SPECIAL SERVICE LETTER

NUMBER SSI #77

Subject: Windnoise and Water Leak Corrections - 1969 Ford & Mustang

Subject: Windnoise and Water Leak Corrections - 1969 Ford & Mustang

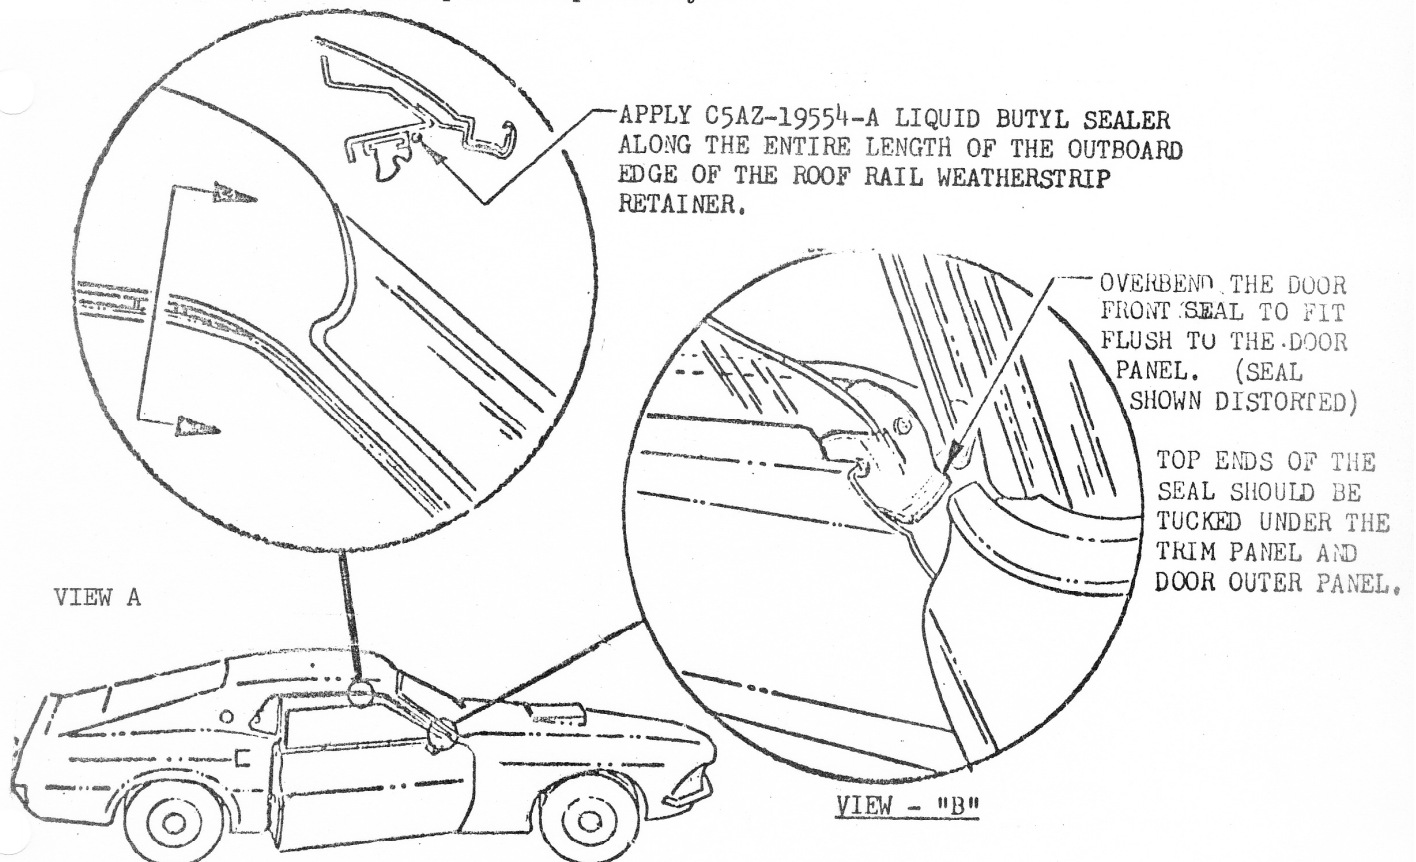
Problem and Cause: 1969 Mustang - All Models

A windnoise occurs at the door glass to "A" post at the belt line. This problem is due to an inadequate seal between the weatherstrip retainer and the "A" post and/or poor fit and coordination of the front door seal assembly to the door inner panel.

The weatherstrip retainer problem was corrected approximately 8-20-68 by adding an additional thickness of sealing tape under the retainer in the belt area. The front door seal assembly was revised approximately 9-7-68 providing a smooth sealing surface for the roof rail weatherstrip.

Apply C5AZ-19554-A sealer along the outboard edges of the weatherstrip retainer for the entire length of the "A" pillar. This is illustrated in View "A". Also, visually inspect the fit of the front door seal to the door inner panel. Assure that the seal is installed as shown below (View "B"), is free from damage and that the retaining screws are tightened securely.

Note: The top ends of the subject seal should be tucked under the trim panel and door panel respectively.

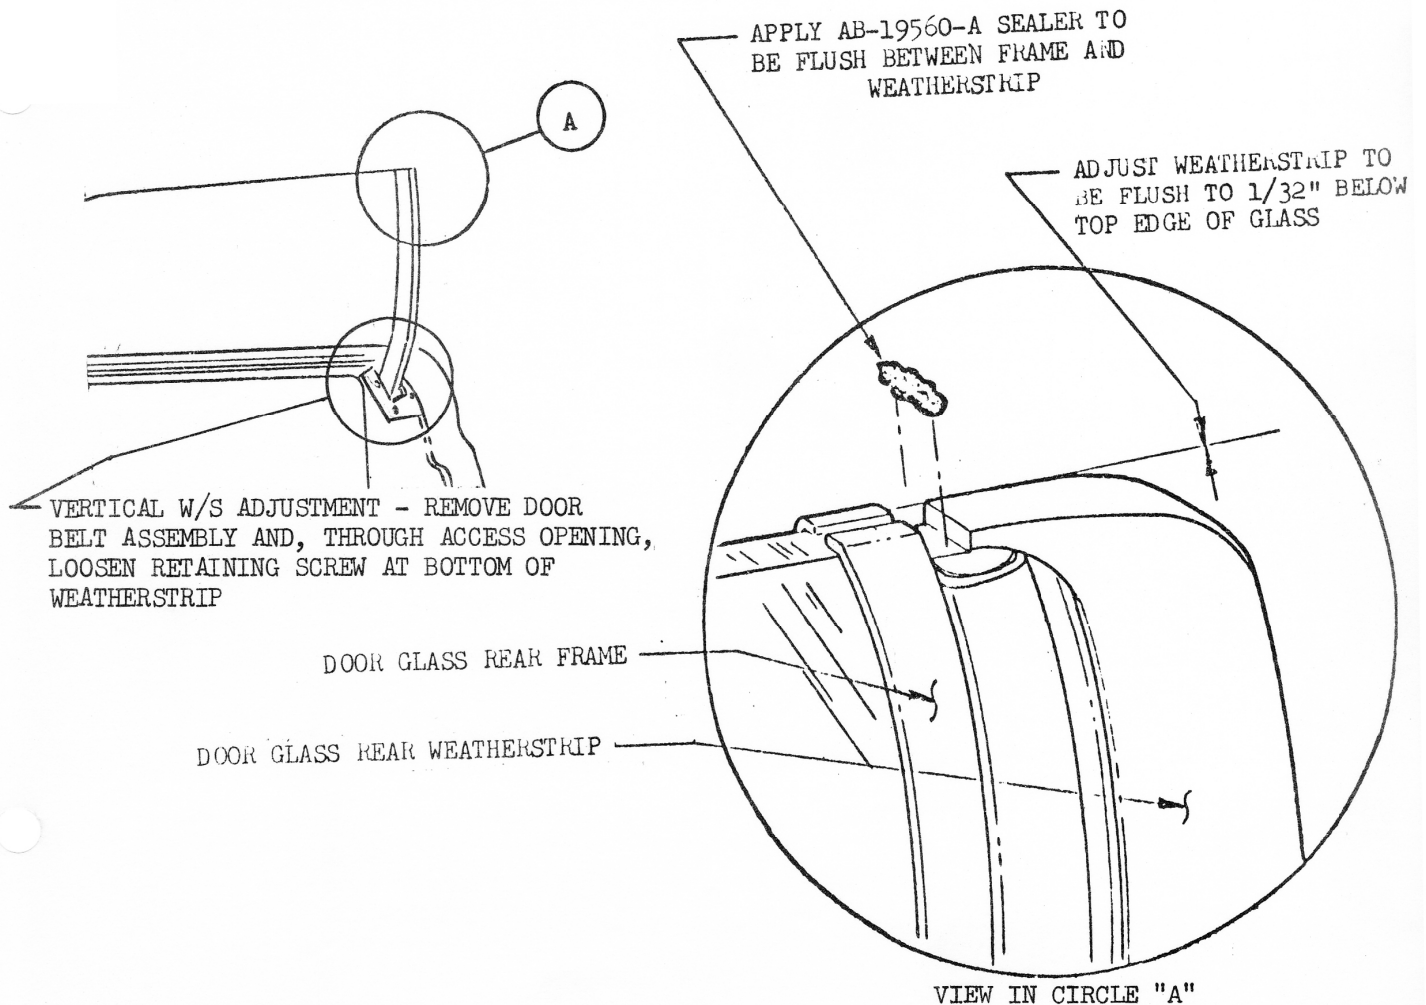
A windnoise occurs at the top of the door vertical weatherstrip, when the weatherstrip is adjusted too high causing interference with the roof rail weatherstrip, or when the slot between the vertical weatherstrip and the retainer is not adequately sealed.

The upper portion of the frame was revised and the lip of the weatherstrip was enlarged to eliminate the gap. (Effective in production approximately mid-September).

The adjustment of the vertical weatherstrip should be checked to ensure that it is flush to 1/32" below the top of the glass. If adjustment is required it is made at the bottom of the weatherstrip retainer after removing the front door belt assembly. The windnoise can result from a small unsealed gap between the door glass rear frame and the top of the door glass rear weatherstrip. To correct this it may be required to add a daub of AB-19560-A sealer flush between the top surfaces of the frame and weatherstrip.

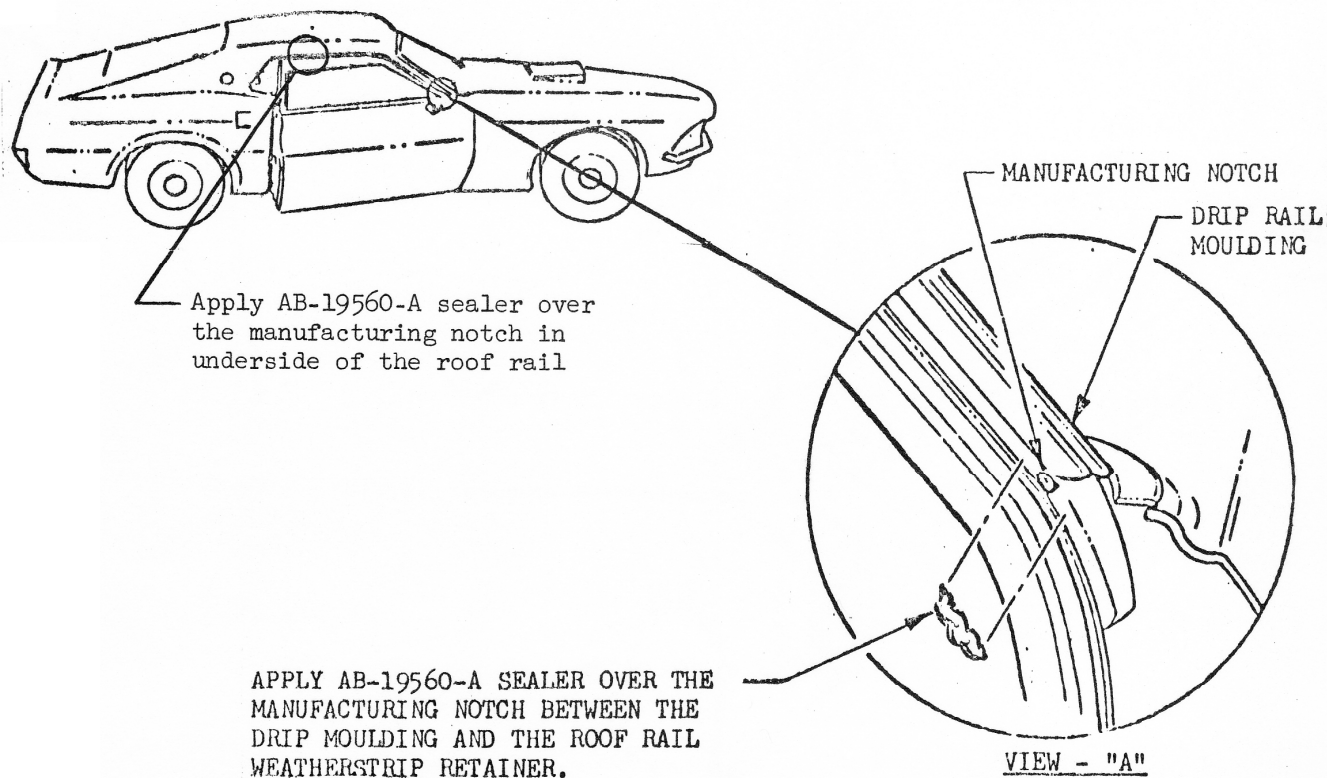
A windnoise is heard above the door opening through the headliner in the area of the drivers or passengers ear. There are two sources for this noise which are some distance from where the noise is heard. The first source is at the "A" post belt area where a manufacturing notch is not adequately sealed. This allows the air to enter the hollow roof rail section and transmit the noise through an opening behind the headliner. The second, is in the underside of the roof rail approximately 8" forward of the 1/4 glass area and outboard of the roof rail weatherstrips. This is also due to a manufacturing notch which may not have been adequately sealed.

Both of the above conditions were corrected in the assembly plants approximately mid-September by sealing the problem areas.

The manufacturing notch in the "A" post belt area can be sealed with AB-19560-A sealer as illustrated in the sketch below, view A. The notch is located outboard of the weatherstrip but the hollow roof rail transmits the sound into the vehicle above the corresponding door opening. The manufacturing notch located in the underside of the roof rail can also be sealed with the AB-19560-A sealer to eliminate noise into the vehicle through the hollow roof rail.

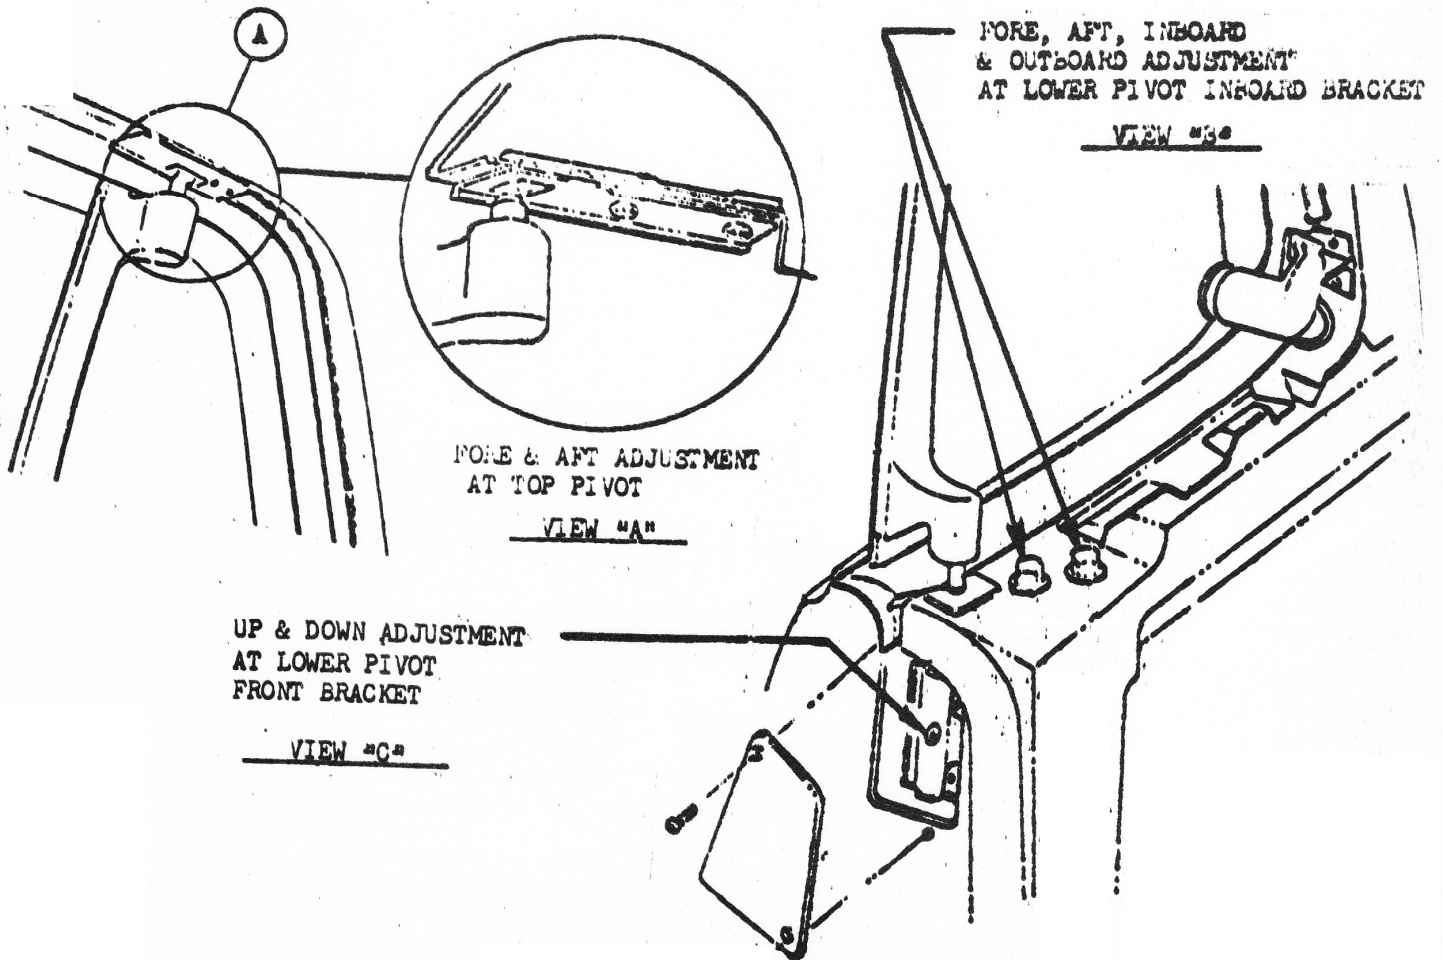
Water leaks and wind noise occur in the quarter vent area due to a poor seal between the quarter vent window glass and the roof rail weatherstrip.

Effective approximately mid-September, 1968 correct quarter window alignment procedures were re-emphasized at all assembly plants.

Properly adjust the quarter vent window to achieve an effective seal by utilizing the following adjustments:

1. Fore and aft at the top pivot (2 screws). Refer to view "A" of the attached sketch.
2. Fore, aft, inboard and outboard at the lower pivot inboard bracket (2 screws). Refer to view "B" of the attached sketch.
3. Up and down at the lower pivot front bracket (1 screw). (See View "C")

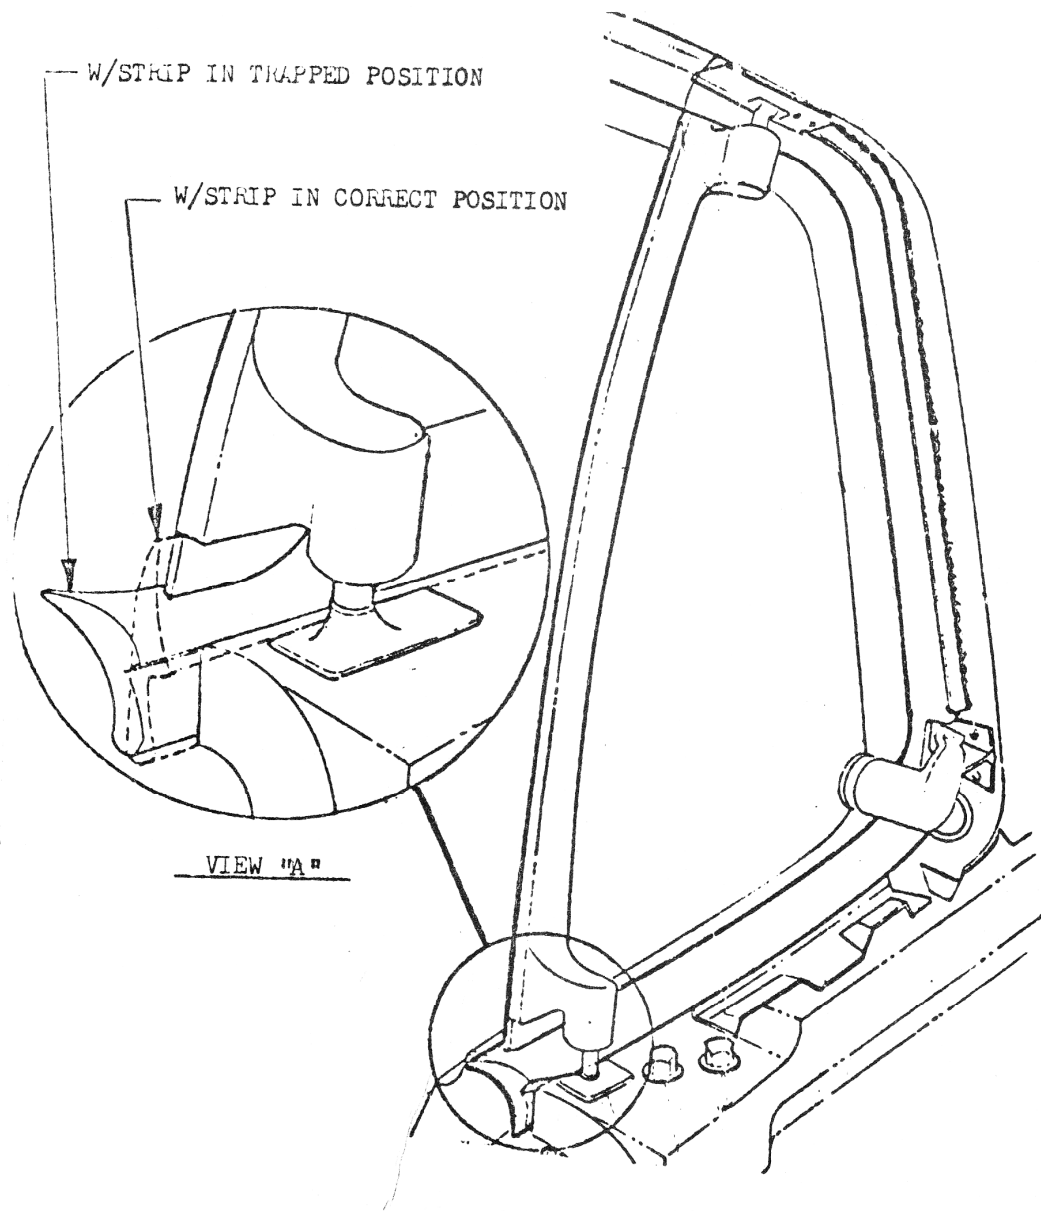
Water leaks and wind noise occur at the quarter belt area due to the upper lip of the roof rail weatherstrip, at the top of the lock pillar, being trapped under the vent window vertical frame.

All plants were instructed during mid-September as to the correct installation procedure and location of the weatherstrip.

Pull the subject lip from under the frame and locate it in the side notch on the inboard side of the vertical frame as shown on the attached sketch, view "A".

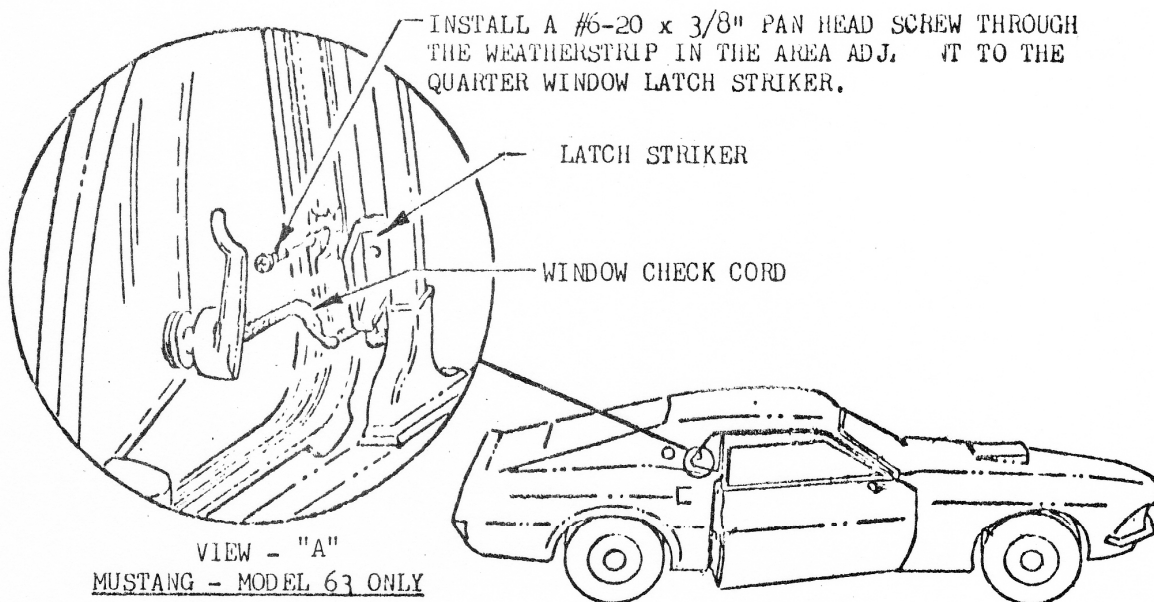
A wind noise and water leak may occur at the quarter window to roof rail weatherstrip in the area of the "C" pillar, when the curved portion of weatherstrip is puckered.

Effective in production approximately 9-4-68 a screw was added to secure the weatherstrip in the problem area.

Drill a 1/8" diameter hole through the weatherstrip, the retainer and into the roof rail in the area adjacent to the quarter window latch striker. Secure the weatherstrip with a #6-20 x 3/8" pan head self tapping screw (part #382566-S100) or equivalent. Refer to the attached sketch, view "A".

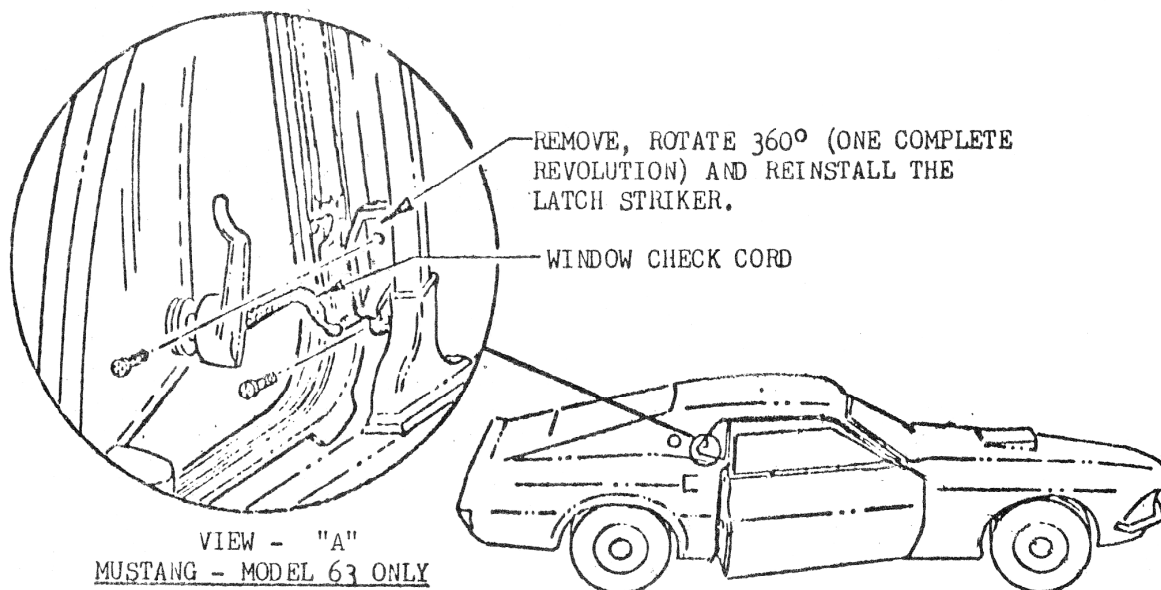
A windnoise and/or water leak occurs at the quarter belt area, when the quarter window check cord becomes trapped between the window assembly and the inner sealing lip of the roof rail weatherstrip.

Effective approximately 8-26-68 the cable connecting clip on the quarter window was rotated to a position 45° rearward from the 6 o'clock position as viewed from inside the vehicle.

1. Unlatch and push open the quarter vent window.
2. Remove the two latch striker retaining screws.
3. Rotate the striker 360° (one complete revolution) in either direction and reinstall with the screws. Refer to the attached sketch, view "A".

Note: Rotating the striker will put a bind on the cord forcing it to kink upwards and away from the weatherstrip.

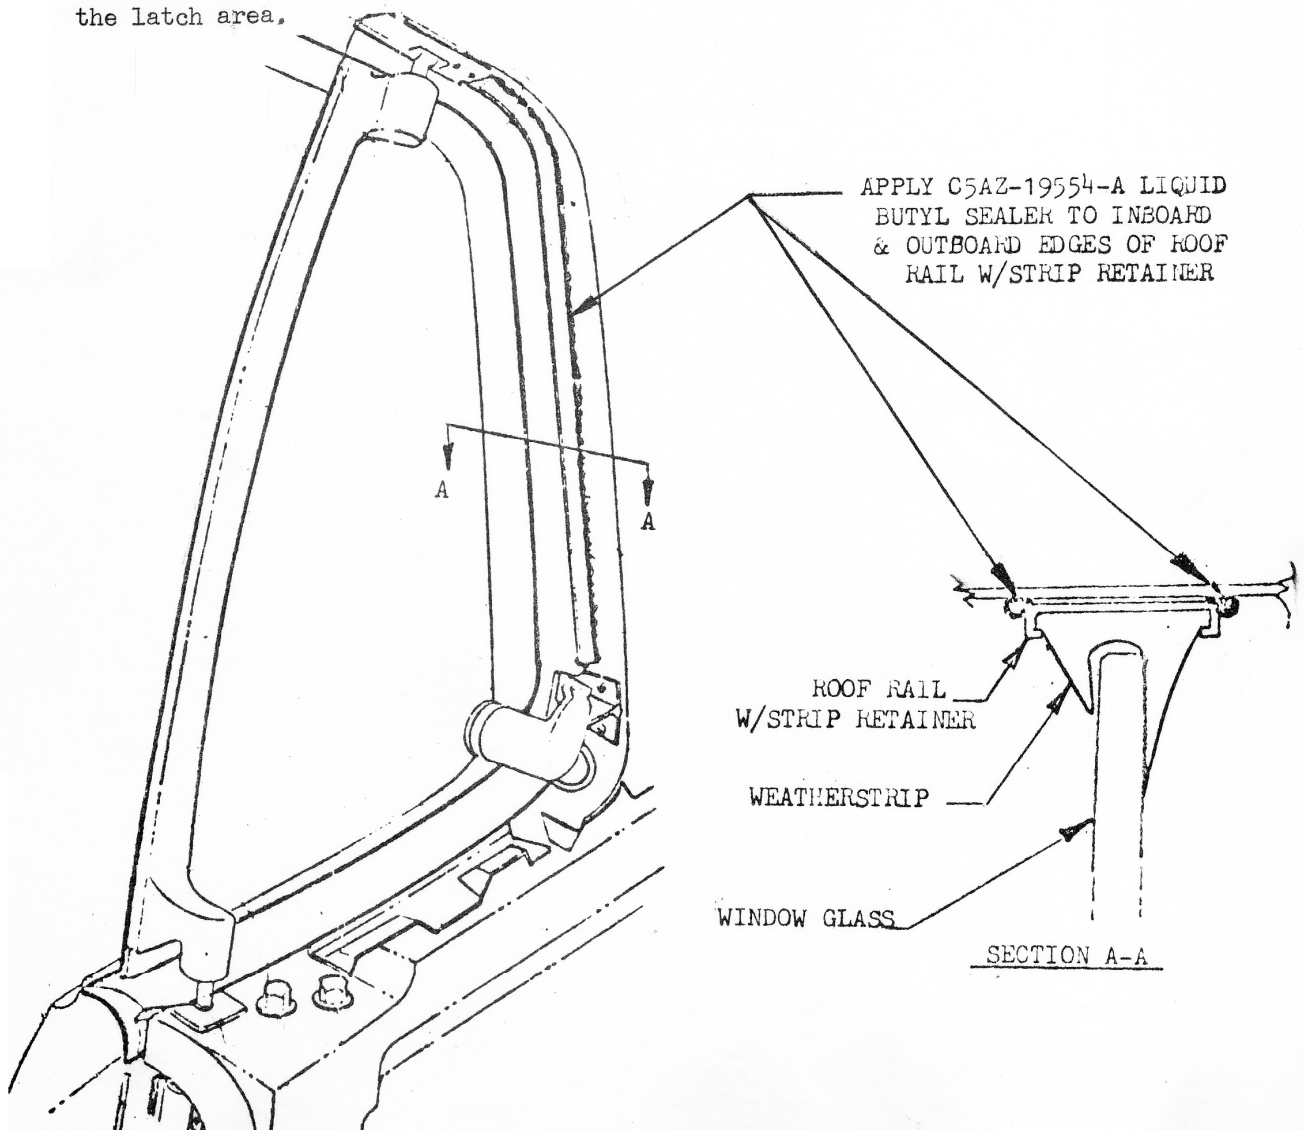
Water leaks and windnoise in the "C" pillar area can be caused by a poor seal between the roof rail weatherstrip retainer and the roof rail.

The production correction implemented approximately September 15, 1968 was to increase the width of the released tape between the roof rail and the roof rail weatherstrip retainer.

Apply liquid butyl (Part No. C5AZ-19554-A) to the inboard and outboard edges of the retainer in the area of the quarter vent window. Refer to the attached sketch, Section A-A. Sealer along the outboard edge of the weatherstrip retainer is important to eliminate water entering behind the retainer and running down into the vehicle at the latch area.
